CHINABERRY SUBDIVISION

Engineering Comments: FINAL PLAT COMMENTS (should be addressed prior to submitting the FINAL PLAT for review and/or signature by the City Engineer):

APPLICATION NUMBER 1 DATE December 5, 2019

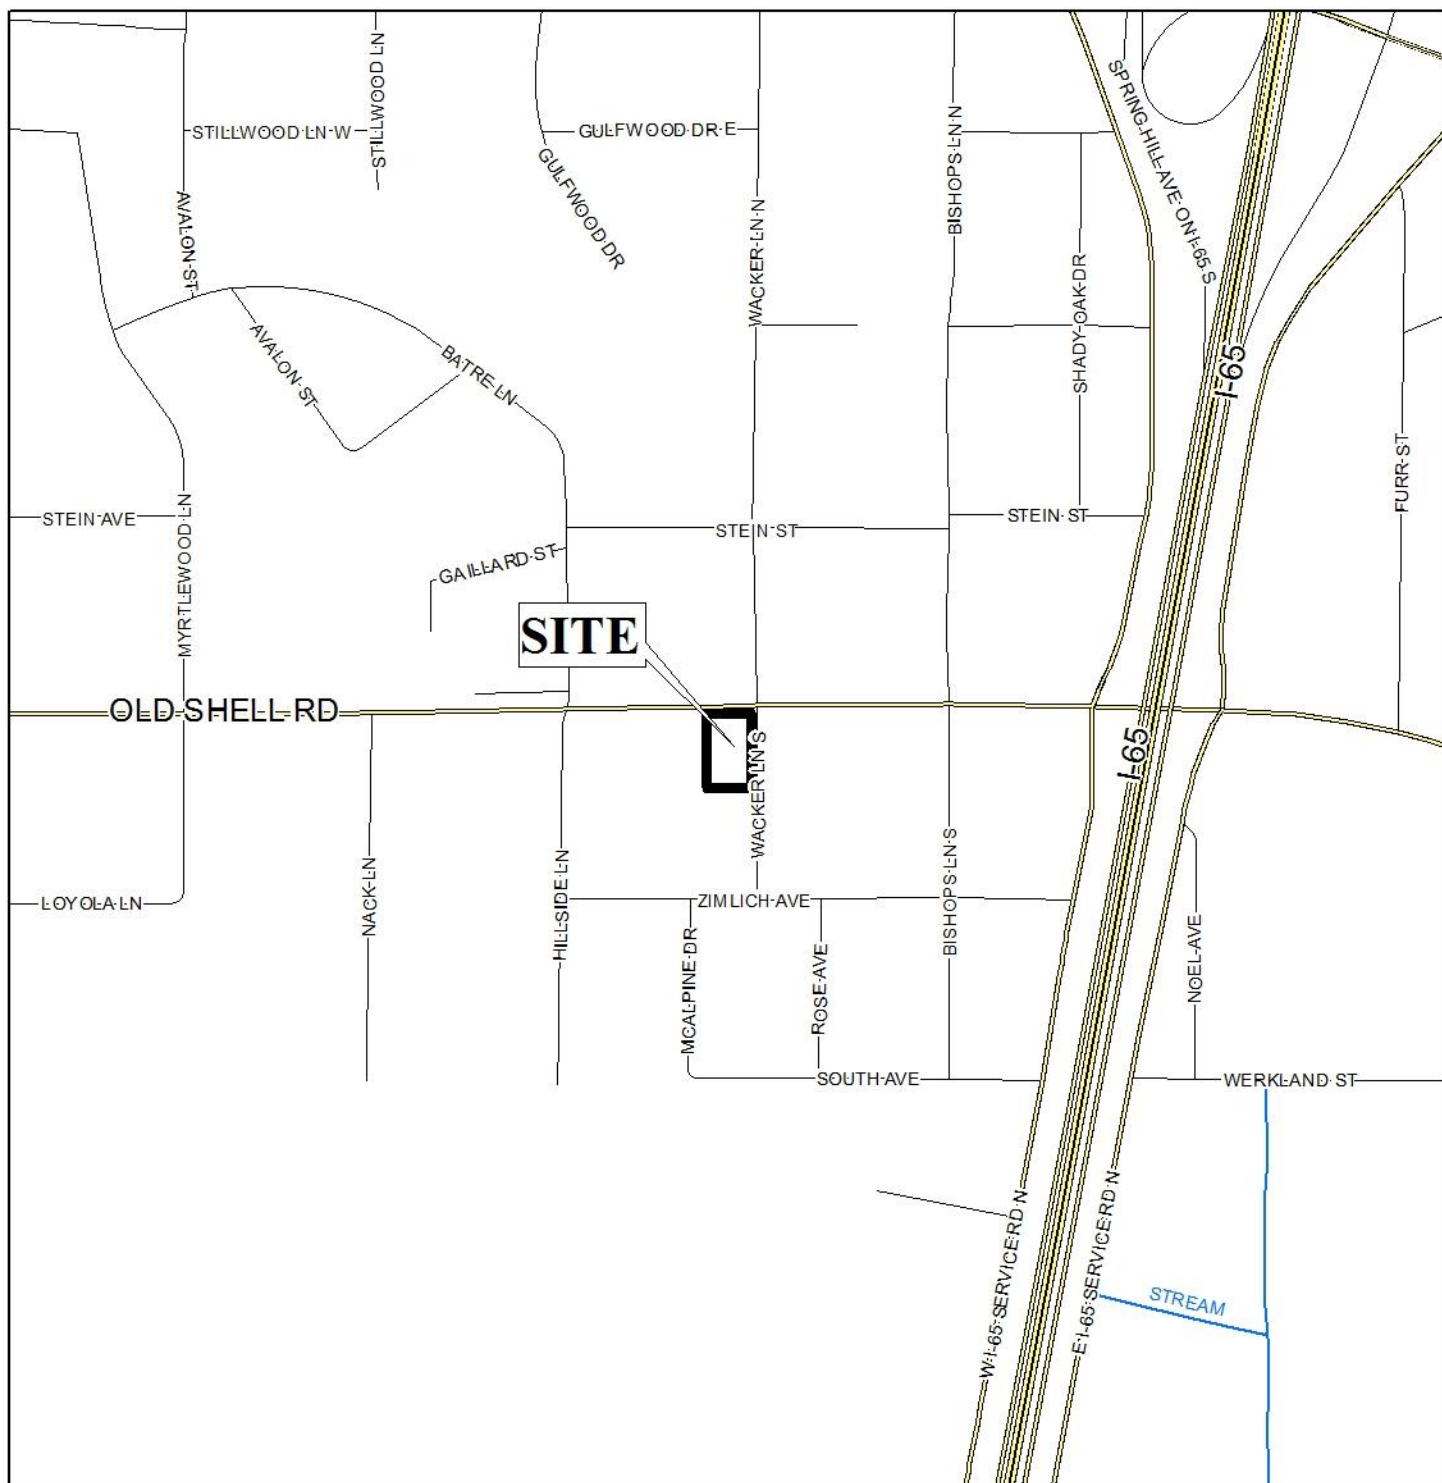
The MHDC is concerned any required right-of-way or setback on the eastern perimeter of the lot and further alteration of the site will be detrimental to the historic nature of the property. Right-of-way dedication would impact the historic kneewall and pedestrian gate access onto Wacker Lane. Both right-of-way and minimum setback requirements could potentially impact the historic brick pathways and plantings at the northeast corner of the lot.

However, the requirements of the Zoning Ordinance would still apply, thus a 25-foot front yard setback along Old Shell Road would be required, but the side yard setback along Wacker Lane could be reduced to 20 feet (*with or without setback to accommodate possible future widening*). The setback requirements of the Subdivision Regulations and the Zoning Ordinance only impact new construction of vertical structures, not site elements such as parking areas or existing buildings (*unless they are expanded*).

Given the unique issues of this site due to its historic nature, a waiver of the standard requirements of the Subdivision Regulations may be appropriate.

Based upon the preceding, and with a waiver of Sections V.B.14., V.B.16., V.D.6. and V.D.9. of the Subdivision Regulations, the application is recommended for Tentative Approval, subject to the following conditions:

- 1) Revision of the plat to depict a 25-foot setback along the Old Shell Road frontage, or as may be approved by the Board of Zoning Adjustment, if requested;

- 2) Revision of the plat to depict a 20-foot setback along the Wacker Lane South frontage, reflecting additional setback sufficient to provide 25-feet from centerline along Wacker Lane South, or as may be approved by the Board of Zoning Adjustment, if requested;

- 3) Coordination with the City Engineer regarding any corner radius is requirements;
- 4) Compliance with Traffic Engineering comments, and placement of the comments as a note on the final plat (*Lot is denied access to Old Shell Road and limited to one curb cut to Wacker Lane with size, location and design to be approved by Traffic Engineering and conform to AASHTO standards.*);
